Erratum

"Lead-Acid Battery: Positive Grid Design Principles," B.S.T.J., Vol. 49, No. 7, September 1970, pp. 1279-1303, by A. G. Cannone, D. O. Feder and R. V. Biagetti.

Fig. 14—Rate constant (k) on log scale vs $1/T (^{\circ}\text{K})$ for $5\text{-}5/8'' \times 5\text{-}7/8'' \times 1/4''$ thick PbSb grids.

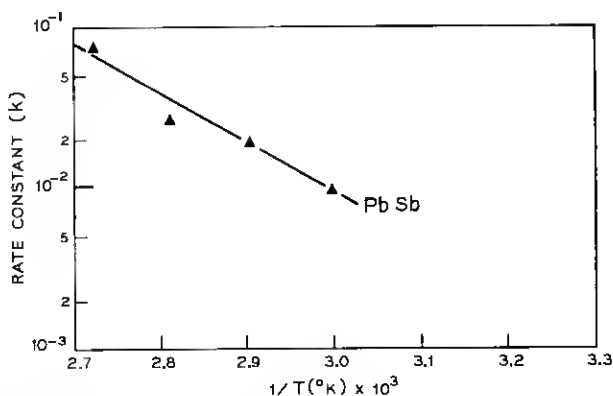
The log scale shown on Fig. 14 (p. 1291) for the rate constant (k) is in error by a factor of ten. It should be:

This is a plotting error only and does not alter the data nor the conclusions shown.
